Washington State Convention Center Addition Project

Design Review Board Design Recommendation Meeting 02
07-19-2016

SDCI PROJECT # 3020176

06
**2 DR 01 COMMENTS
BOARD
RECOMMENDATIONS**

PINE ST ELEVATION

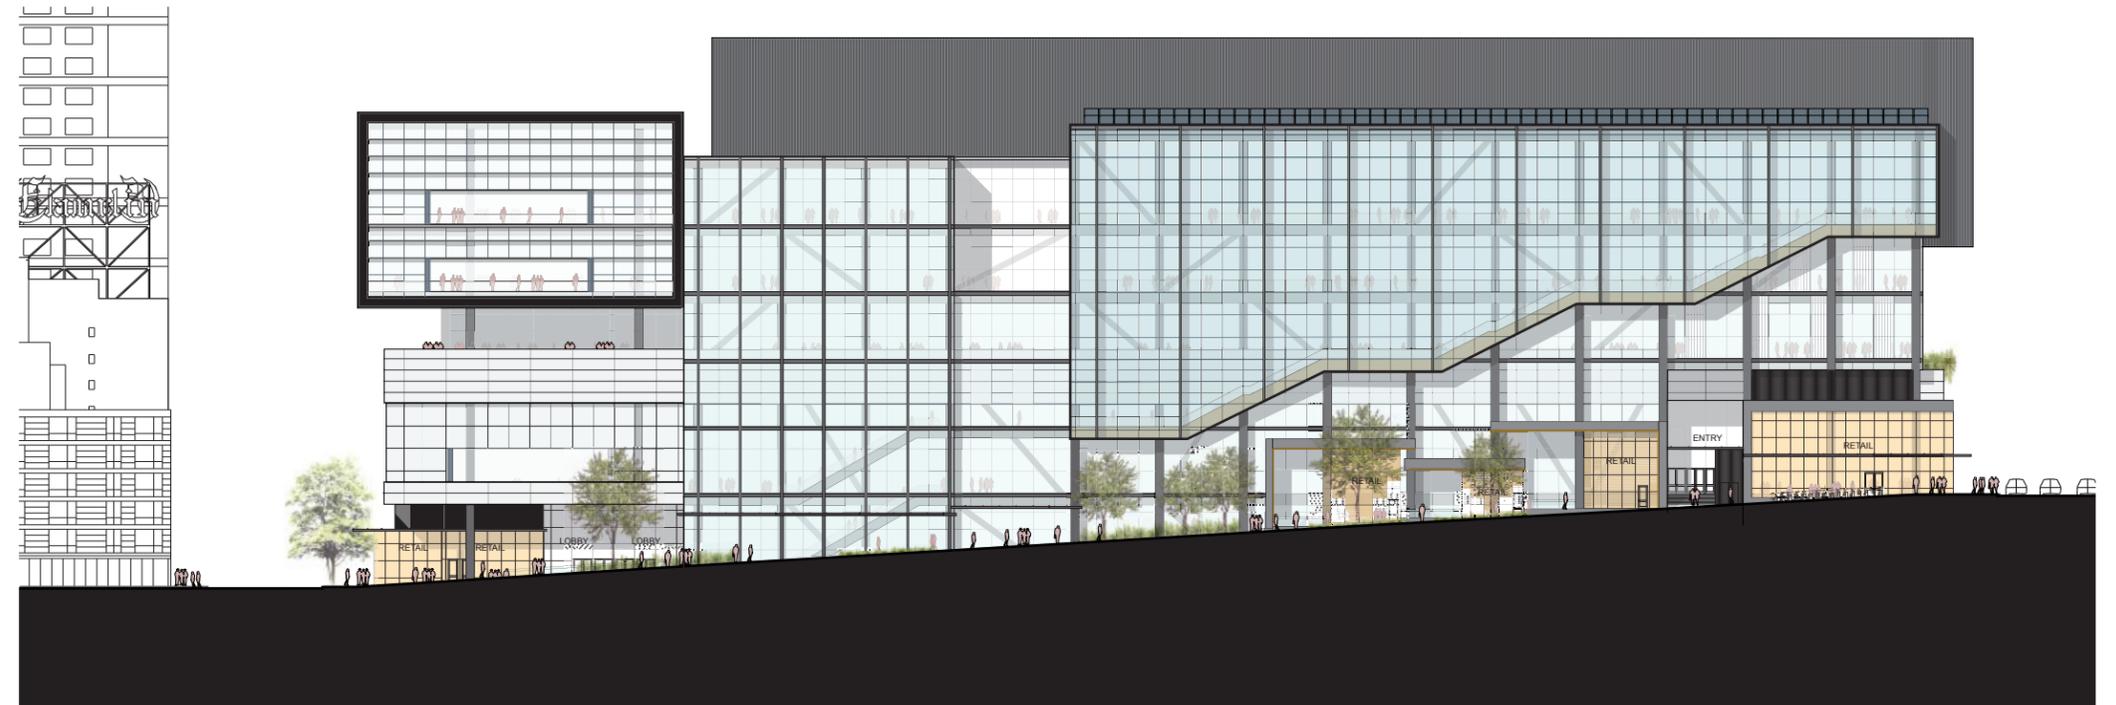
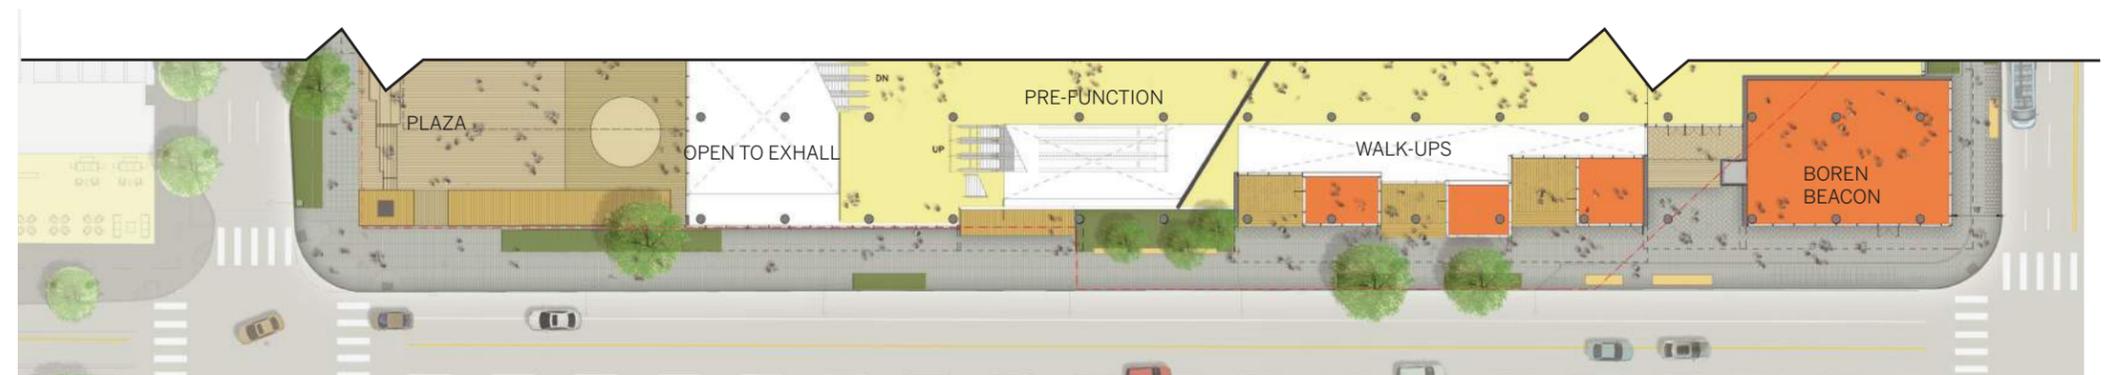
COMMENT 2A - PINE STREET

The Board supported the floor area sizes and alternation of enclosed merchants and open decks basically at sidewalk grade, as shown on page 89, but agreed exploration of the elevations at the middle-east portion on Pine is warranted. The three fragmented and stepped roofs could be combined to create a single, taller scale that provides an intermediate datum for the projecting stair above to play off of.

COMMENT 2D - PINE STREET

If the soffit under the stair is mirrored [70], the retail roofs and canopies below will require careful design as a visible, reflected surface; the Board had mixed reactions to the mirror in such a strategic location, and detailed light/glare analysis is recommended.

RECOMMENDATION 1 - PINE STREET

Pine Street Stair and Materials: If the soffit under the stair is mirrored [70], the retail roofs and canopies below will require careful design as a visible, reflected surface; the Board had mixed reactions to the mirror in such a strategic location, and detailed light/glare analysis is recommended (item #2d above).

RESPONSE - The design was revised to create a better sense of balance and proportion in relation to the cascading stair above. The retail volumes have been streamlined, while maintaining enough variety and pedestrian interest akin to the quirky character of Capitol Hill.

RESPONSE - The design and organization of the retail on Pine Street has been further studied based on Board guidance to address issues raised and reflect a greater level of detail and refinement of forms and character. The sculptural quality and materiality of the roofs are expressed in the soft reflection of the soffit, depicted in the rendering on page 99, which was also evaluated for potential adverse effects.

9TH AVE ELEVATION OF MIXING ZONE

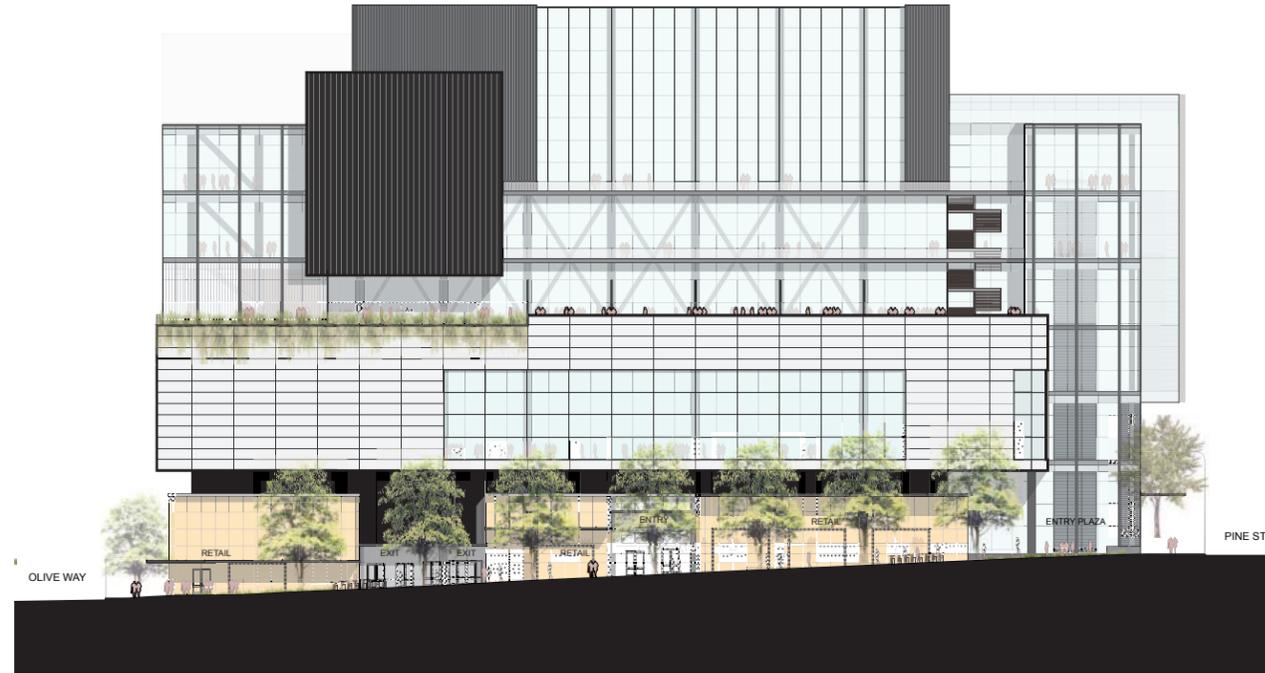
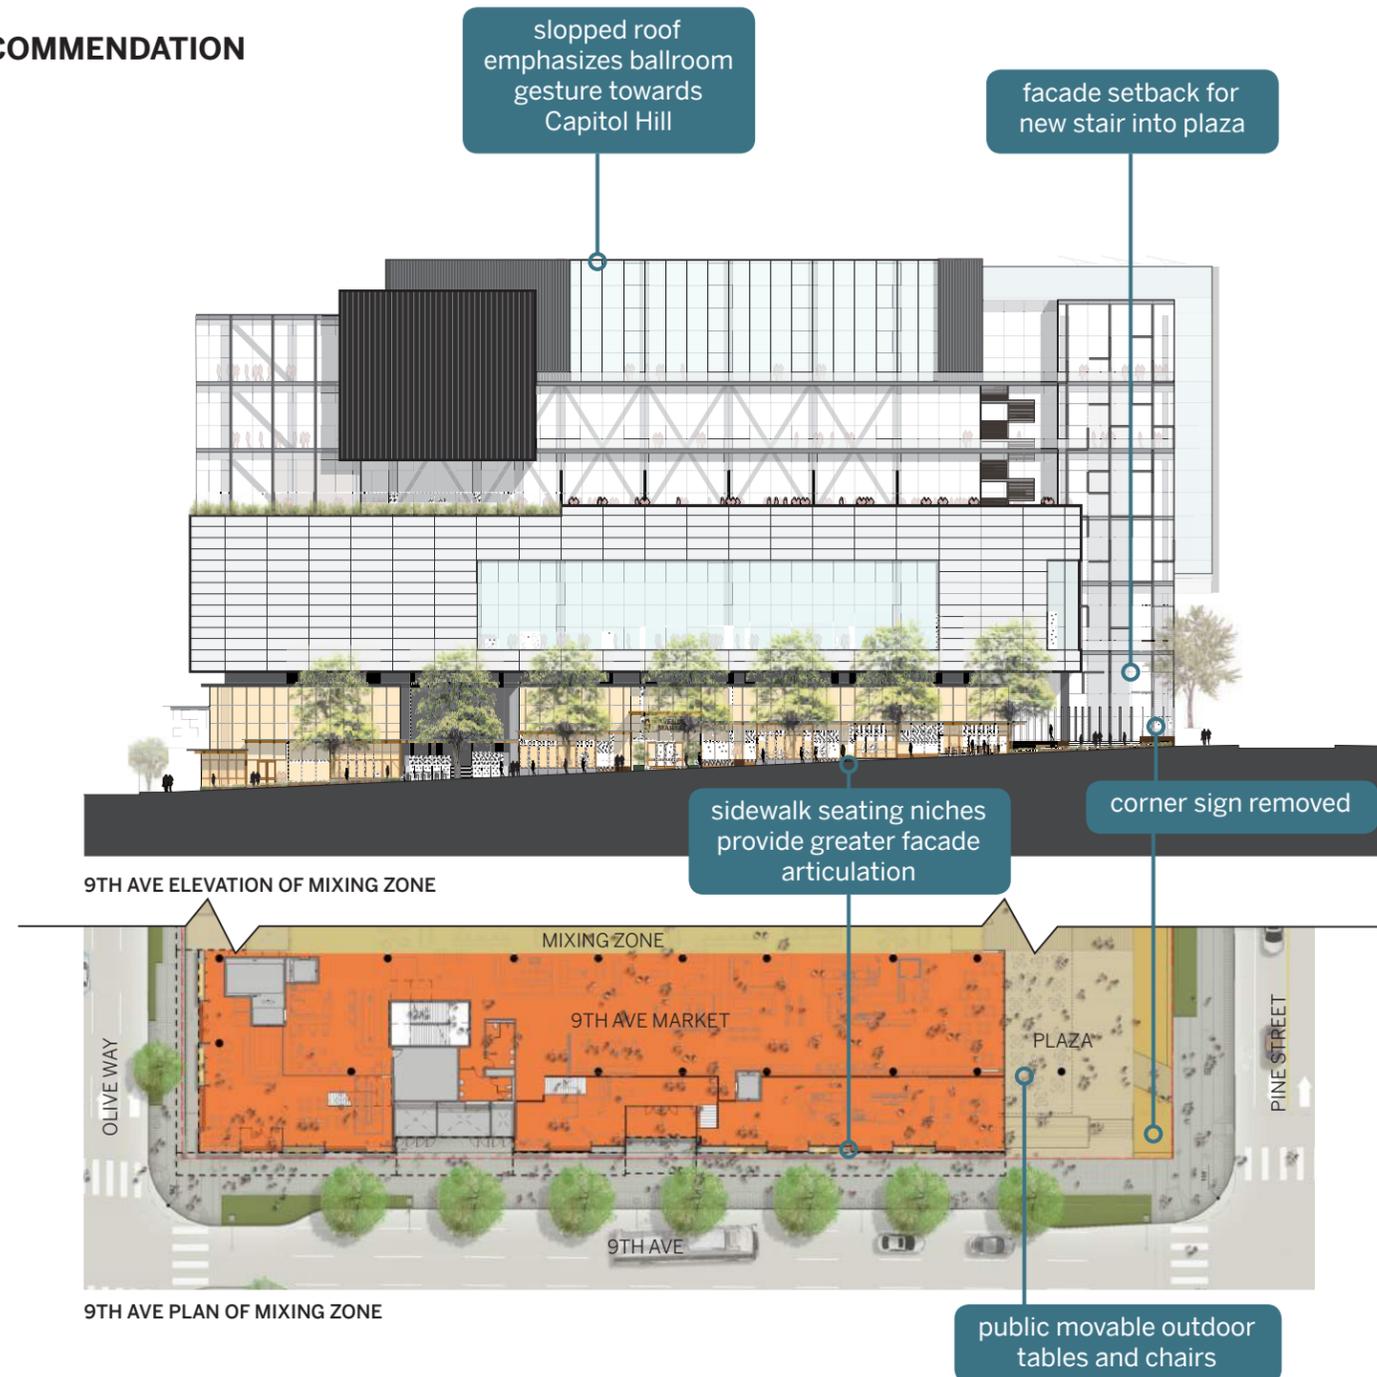
RECOMMENDATION 2 - 9TH AVENUE

9th Avenue modulation and Pedestrian Amenity: Large scale cross sections at several points on the 9th Avenue frontage, and spot elevations on all plans, shall be provided at subsequent meetings, to ensure the guidance described under #5 above.

RESPONSE - The requested sections have been provided on pages 82-83 and plan with spot elevations can be found on page 81.

OLIVE WAY ELEVATION

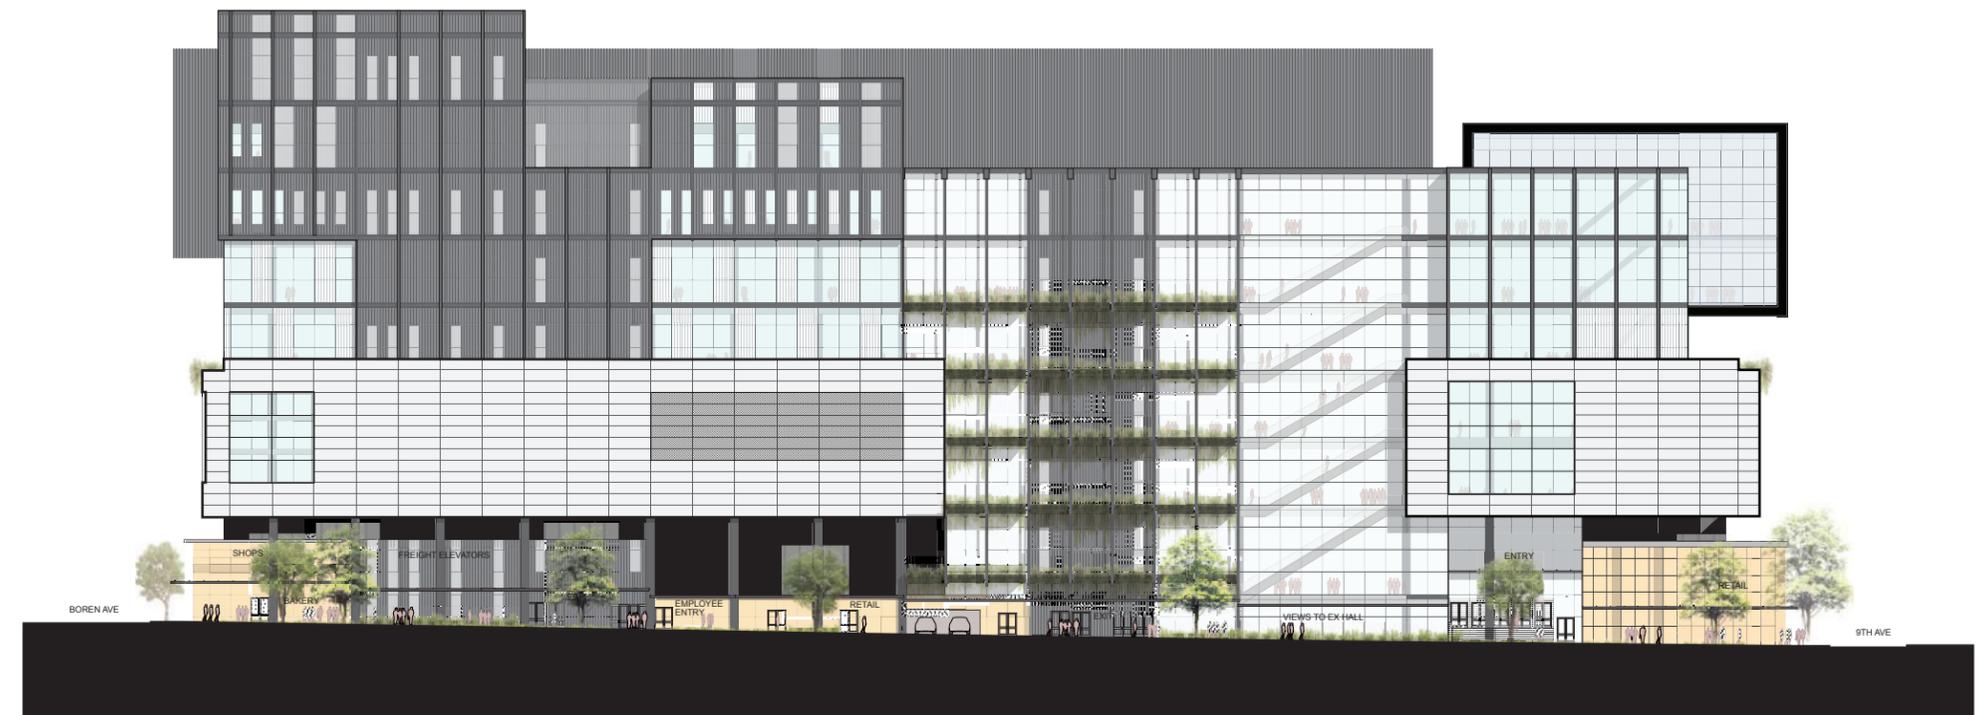
COMMENT 4B - OLIVE WAY

The Board strongly endorsed pedestrians being able to look down into the below-grade lobbies (see 2b above), and recommended the wide planter at this location [91] be eliminated or substantially narrowed for a substantial length of the open void.

COMMENT 4C - OLIVE WAY

The Board agreed the green planter trays provide texture and scale [64/2, 69,74], and a distinctive material for the Terry Avenue terminus, but concurred with public comment and strongly recommended more vertical green mass be concentrated in the lower and west portions of the actual Terry Street axis. This vertical green could help screen the full height blank walls of the exit stairs. Full height 'terrariums' should be explored, that emphasize the experiential quality for people in the interior lobbies and meeting rooms.

COMMENT 4A,D - OLIVE WAY

The Board recommended all exit doors and the parking portal gate [74] be designed with artful treatments and materials consistent with the refined palette presented.

COMMENT 4E - OLIVE WAY

Consistent with EDG guidance, the Board recommended doors into the northwest corner "market" be considered to activate the Olive portion of the busy street corner.

RESPONSE - The planter has been revised to better coordinate with the planting concept for the Olive Way facade, significantly opening the sidewalk to the face of the building to provide better visual access to the floor opening below.

RESPONSE - The concept for the planters on the Olive Way facade has been refined to provide greater interest and a larger scale visual impact that reinforces the Green Street gesture and unique character of the Pacific Northwest. The layout of the planters have been carefully sited to maximize both interior and exterior views, and provide both transparent and dark backdrops to provide either visibility from the interior or help pop the foliage from a distance. The use of planters on the exterior (as opposed to interior terrariums), creates a unified facade scale layer of local planting that provides the greatest benefit to the public, as viewed from the exterior. The planter concepts are illustrated on pages 54 through 60.

RESPONSE - The concept for material and treatment of garage doors is an elegant fine scale custom perforated metal door - example shown on page 32. The exit doors will be finished to blend into adjacent materials, and vary per elevation.

RESPONSE - The primary entry vestibule for the Market is off 9th Avenue, with other entries off Olive and 9th developed with retail tenant.

ENLARGED BOREN AVE ELEVATION

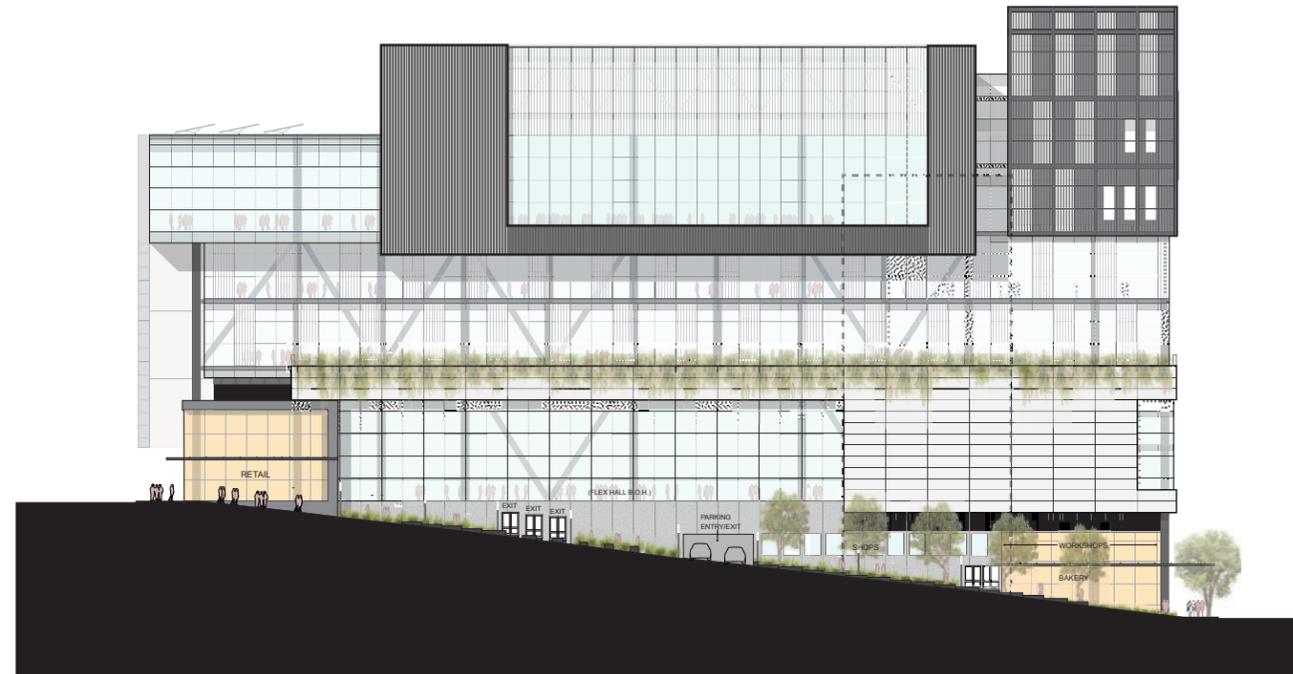
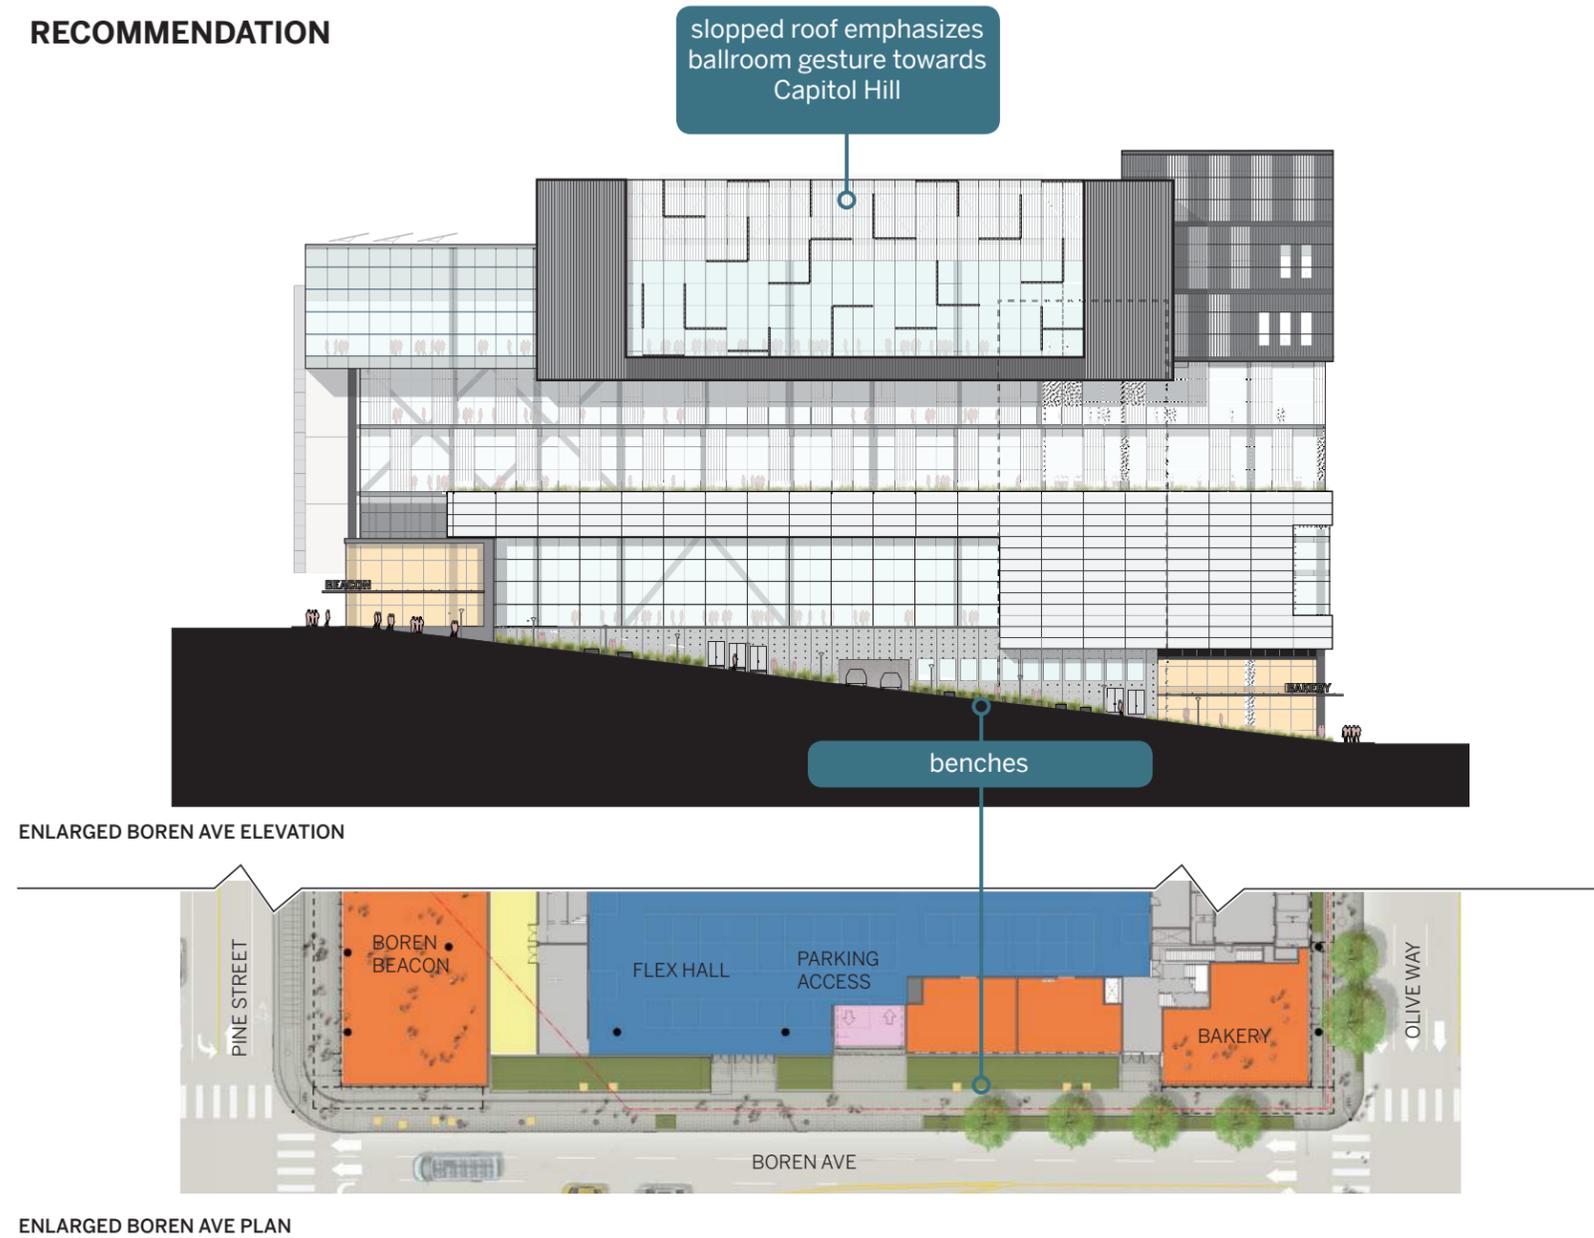
COMMENT 3B - BOREN AVENUE

The Board agreed the steep sidewalk climb warrants the addition of pedestrian resting points adjacent to the sidewalk; benches or seating are recommended at the paved portion for the exit stairs, and another resting recess/feature is advisable at the middle of the planter outside the workshops [93], at roughly third-points (Note: existing projects on steep downtown sidewalks provide landings, assist rails, etc).

COMMENT 3C - BOREN AVENUE

The Board concurred with the public comment and recommended all exit doors and the parking portal gate [53] be designed with artful treatments and materials consistent with the overall refined palette presented [86]. The ground level wall of "textured concrete" is still relatively prominent, so the texture should display multiple scales, tones and shadow-play.

RESPONSE - Benches have been added to create several resting locations spaced along the length of the sloped sidewalk where a corresponding flat surface can be provided for access.

RESPONSE - The concept for material and treatment of garage doors is an elegant fine scale perforated metal door, finished to coordinate with adjacent building facade - example shown on page 32.

The concept for the textured concrete wall on Boren Avenue is to create a landscape texture that will ground the building into its sloping site, and provide a rich backdrop for foreground plantings along the sidewalk - example shown on page 32.
